15 September 2025

**Re: Global Stability Study for Eastern Slope near Building D
West Essex – Highlands Development
West Orange, New Jersey
Langan Project No.: 101049801**

As requested, in conjunction with the above-referenced study Langan Engineering and Environmental Services, LLC (Langan) has reviewed letters prepared by Princeton Hydro ("Princeton"), who has been retained by Objectors to the proposed Development. The Princeton letter, dated 16 July 2025, summarized their comments under four primary issues (below):

Cross Section B (Static Condition)

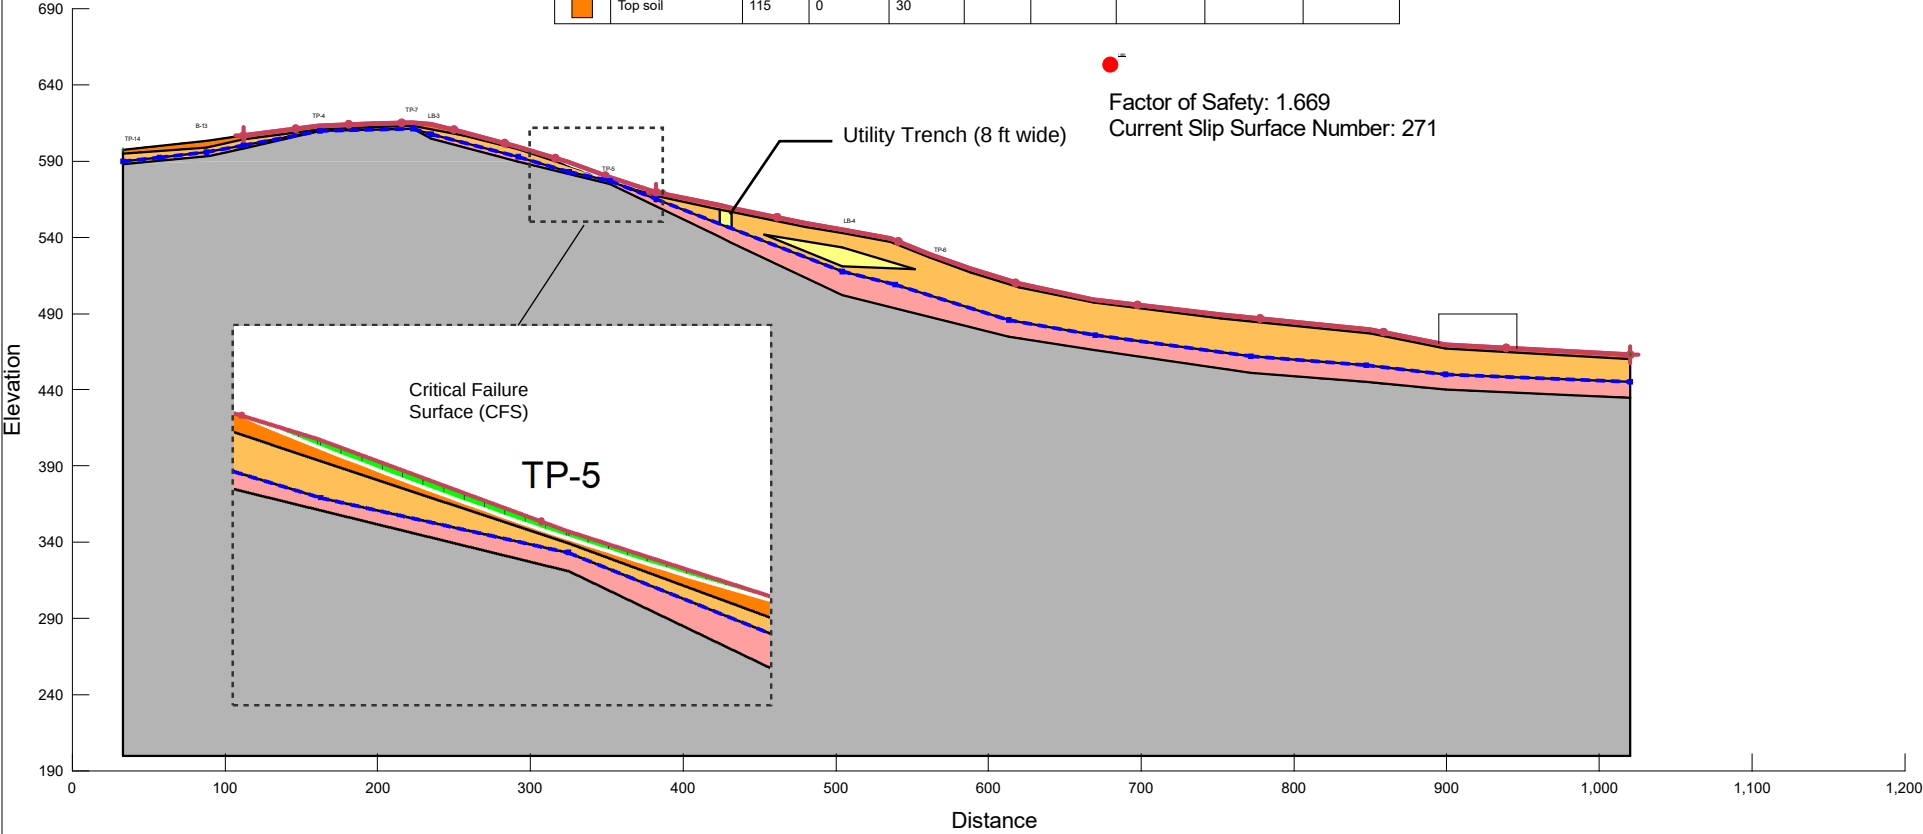
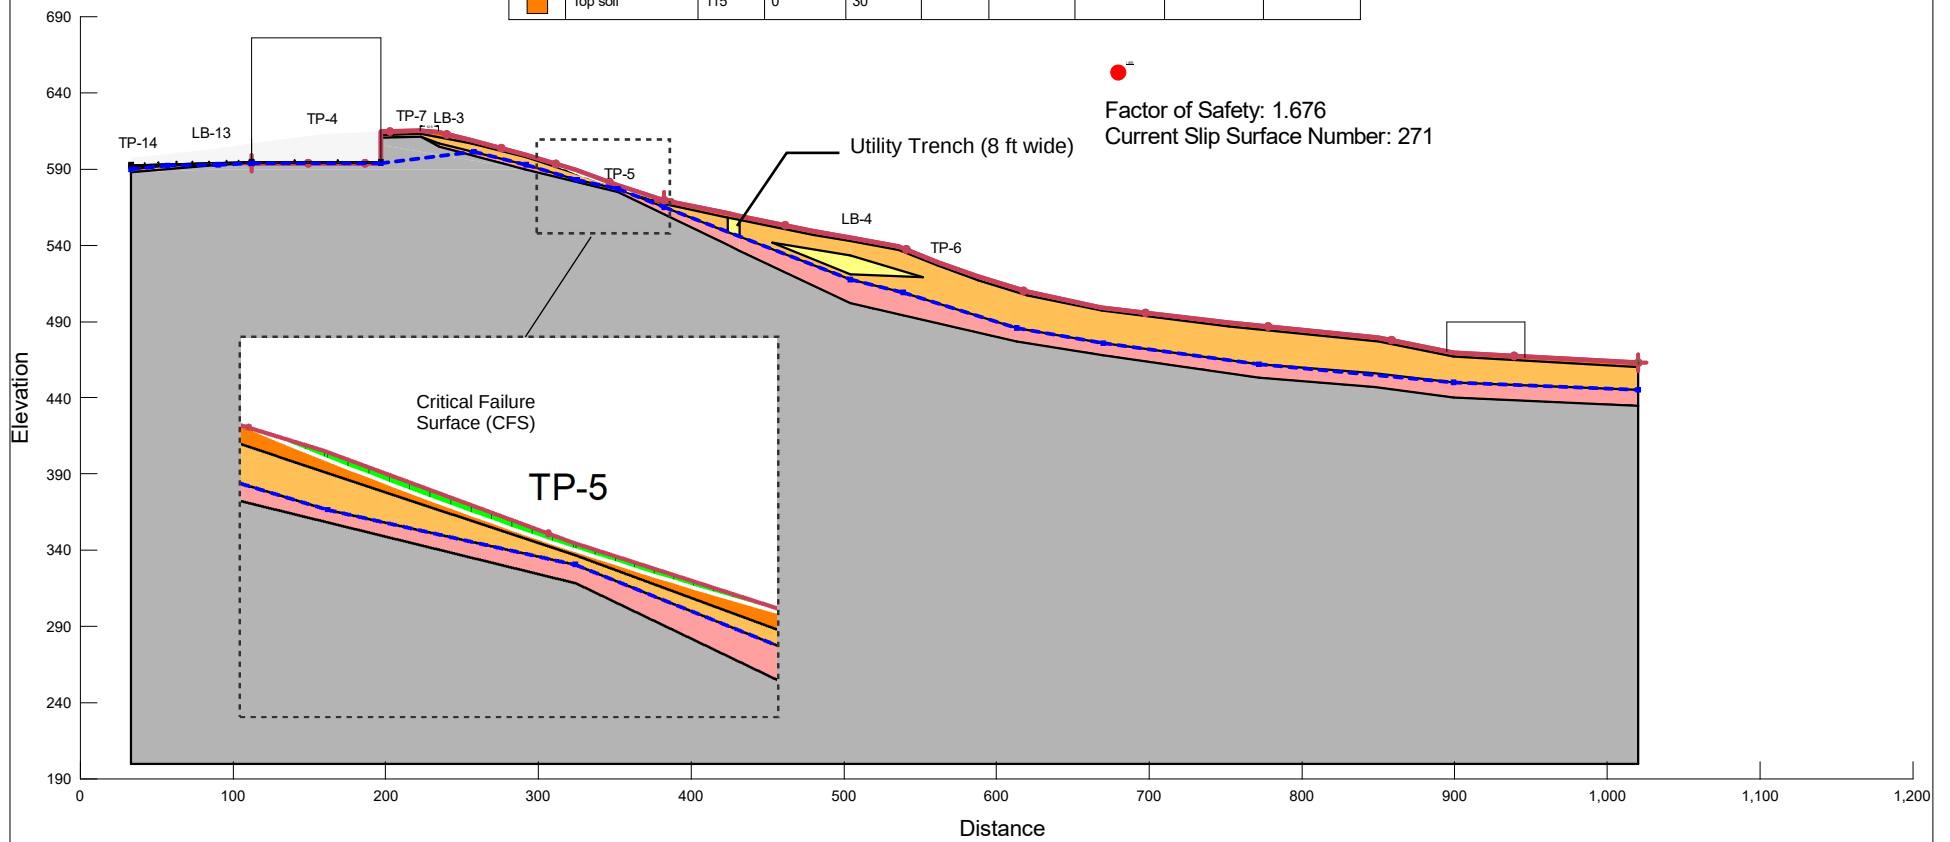
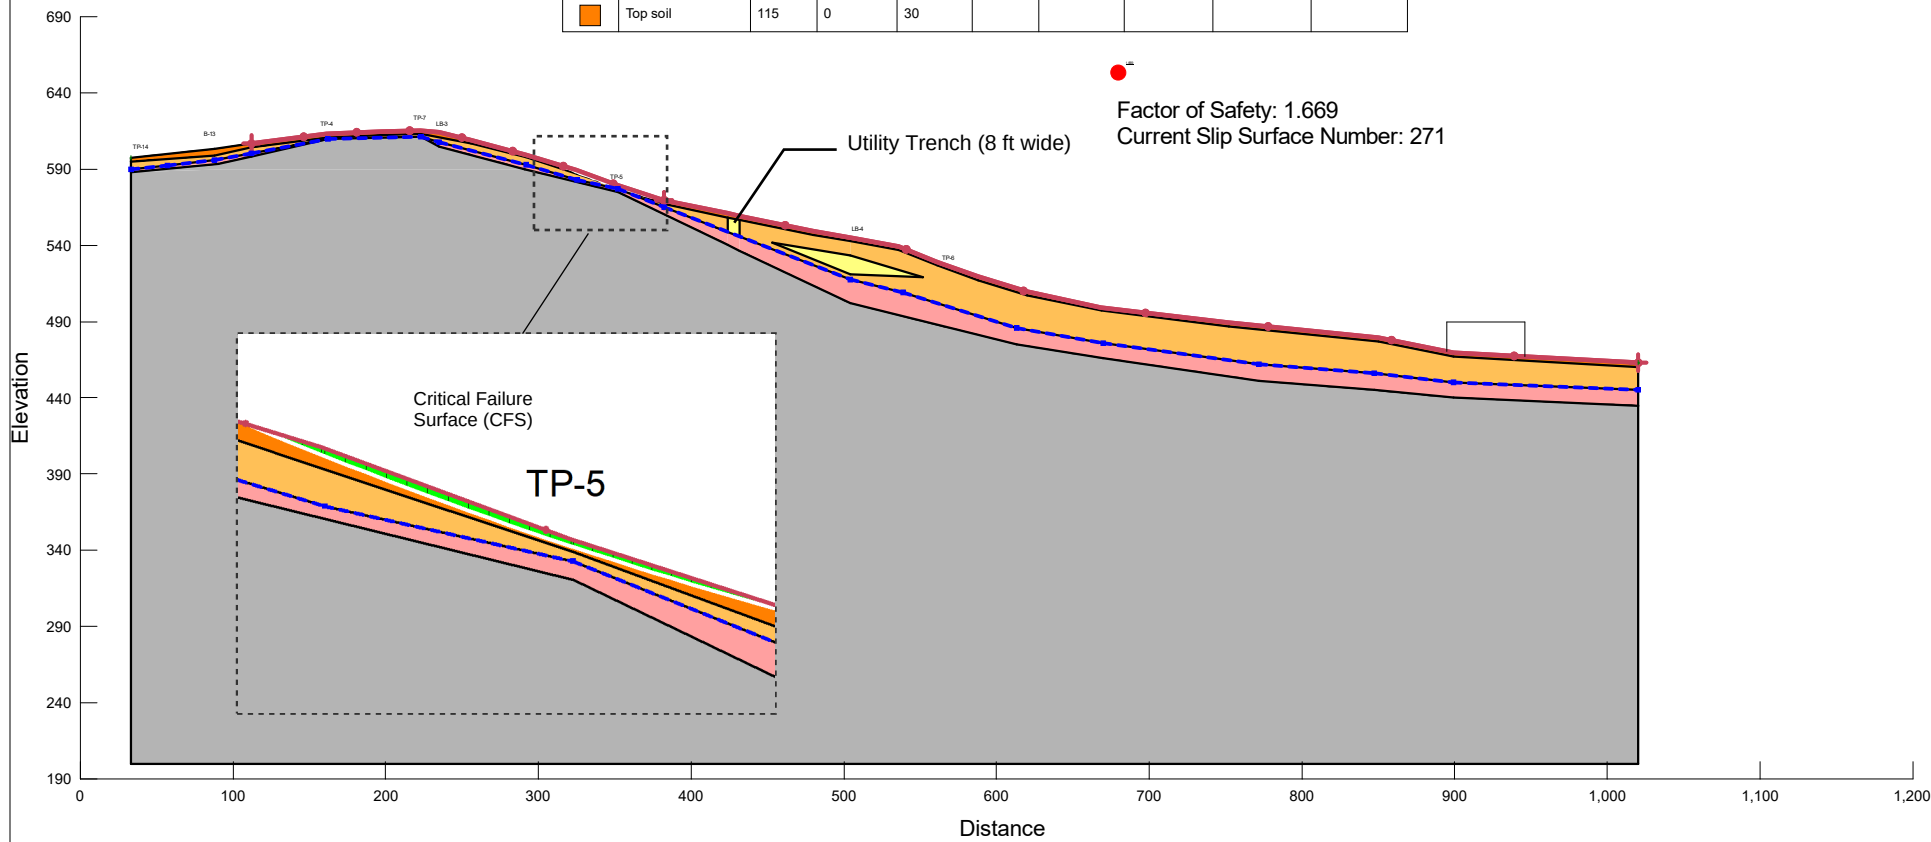
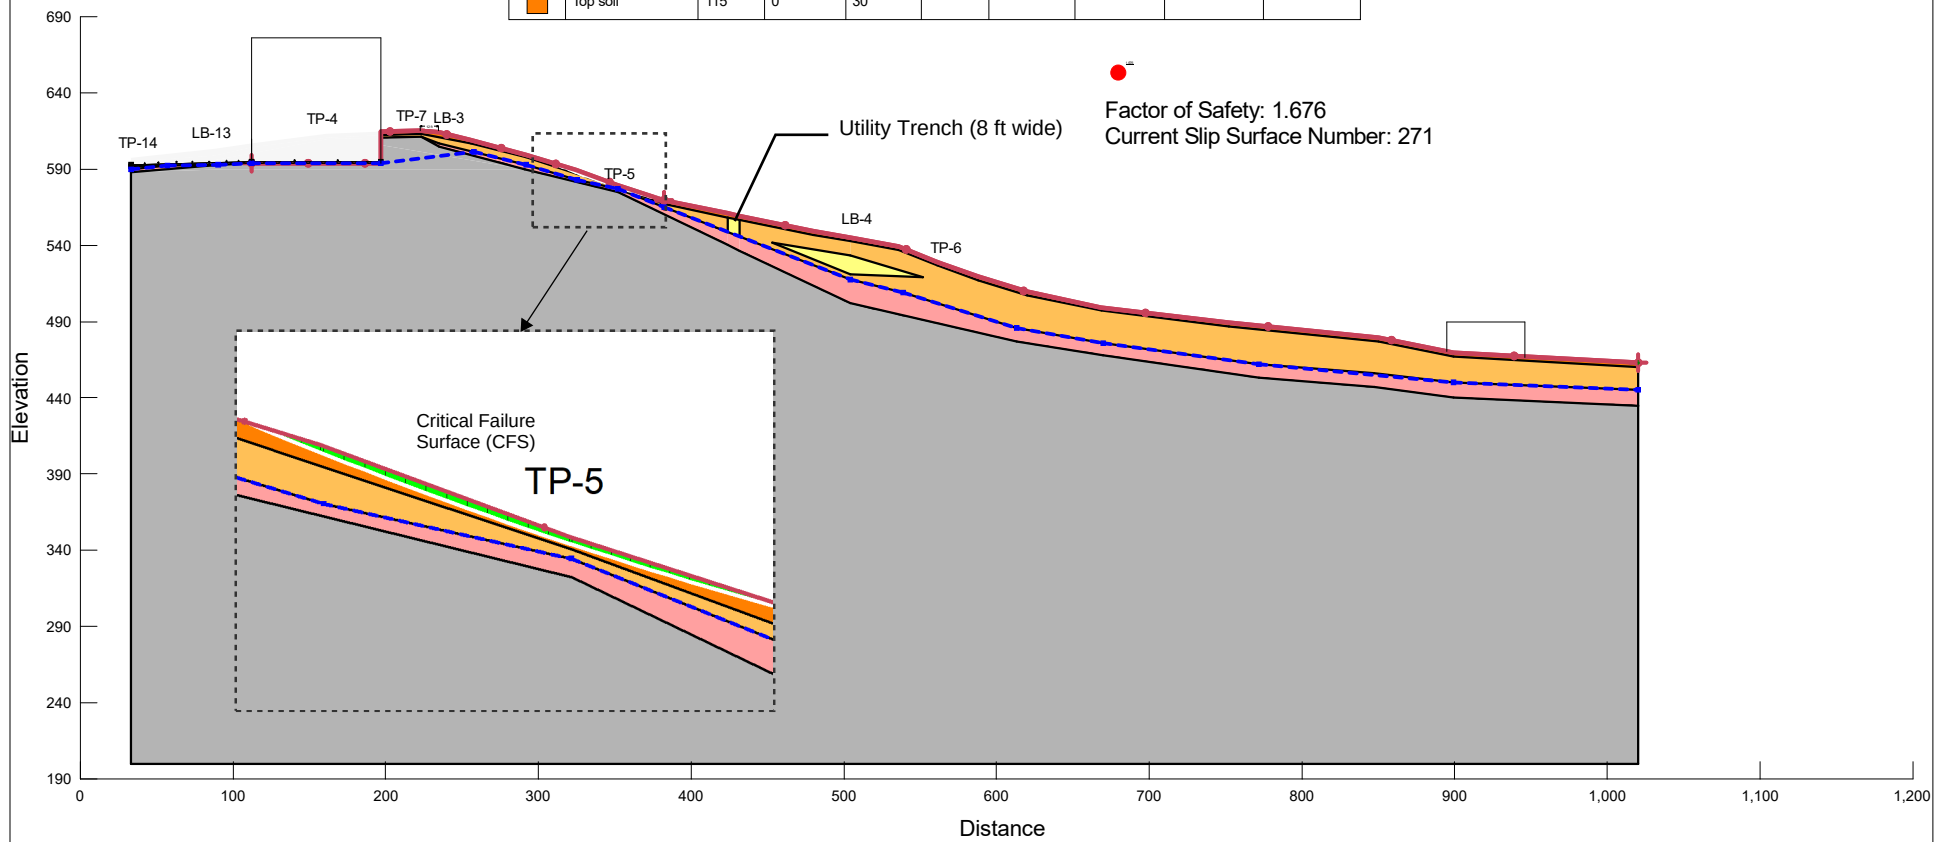
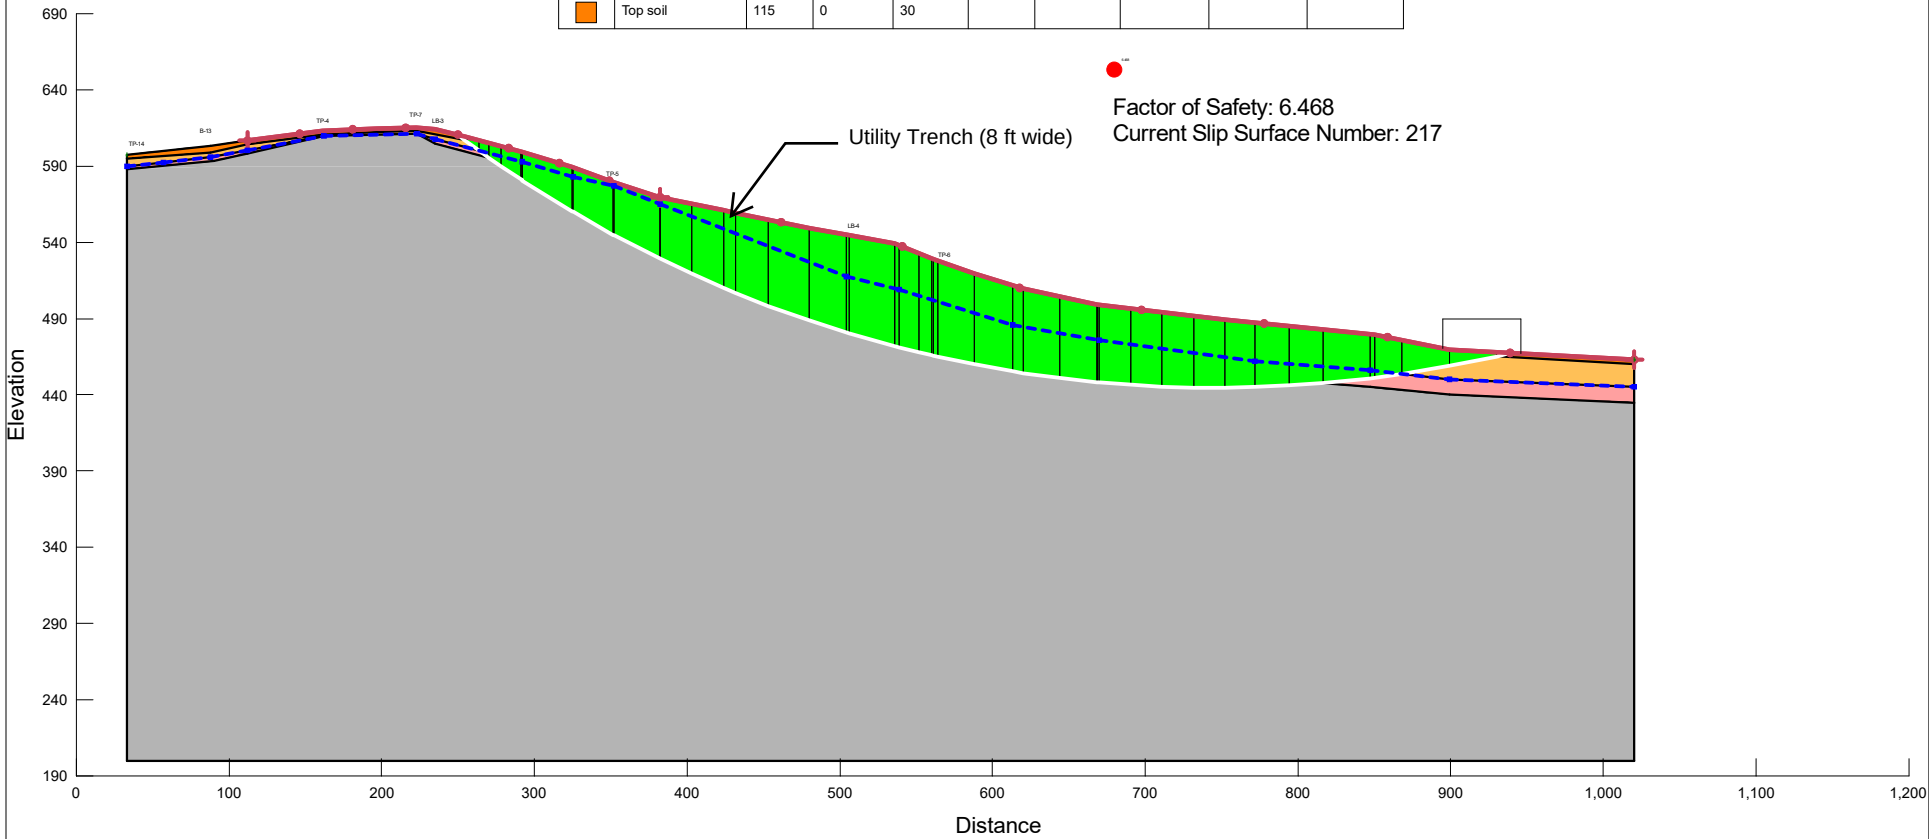
Langan Response: Princeton initially identified seven subparts associated with their position. Five of 7 relate to rock properties used in our model, one relates to building loading, and one relates to the presence of a sewer. In Princeton's 12 August letter they provided analyses using their interpretation of our data. Overall, Princeton repeatedly claims our design values are incorrect, yet they clearly misinterpret the data and mis-apply it.

We modeled our analysis sections A-A and B-B with the discontinuity of the wastewater utility line as a trench of medium dense sand having a friction value of 32 degrees extending from ground surface to the decomposed rock over 30 feet below the existing grade. Our models show that there is no change in the location of the critical failure surfaces or corresponding factors of safety (Exhibit B).
